P5021A-03B-S

# Safety Service Note

## P5021A Keysight Streamline USB Vector Network Analyzer

“POTENTIAL BURN INJURY (HIGH TEMPERATURE) HAZARD”

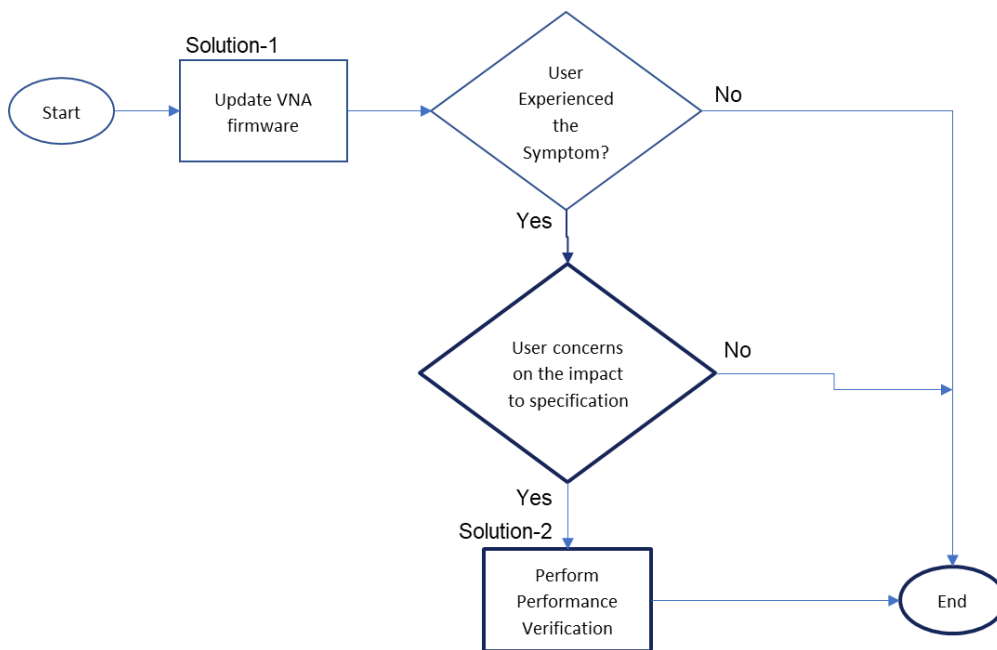
VNA fails to start with the following symptoms.

- 1. LED indicator (below circle) turns red.
- 2. cooling fan does not work
- 3. If user leaves the VNA with this LED indicator red without turning off power switch, it continues to overheat and becomes too hot.

Solution-1: Update VNA firmware by user

Solution-2: Perform Performance Verification by Keysight

1. **Install the latest VNA firmware Rev. A.15.40.13 or newer** on users' controller PC(s).  
The latest firmware enhanced the thermal fan control mechanism.
2. Once the latest firmware is installed, proceed with the restart of both **controller PC** and **VNA**.
3. Launch the VNA firmware. Ensure VNA powers up and launches into firmware correctly after firmware update is done.
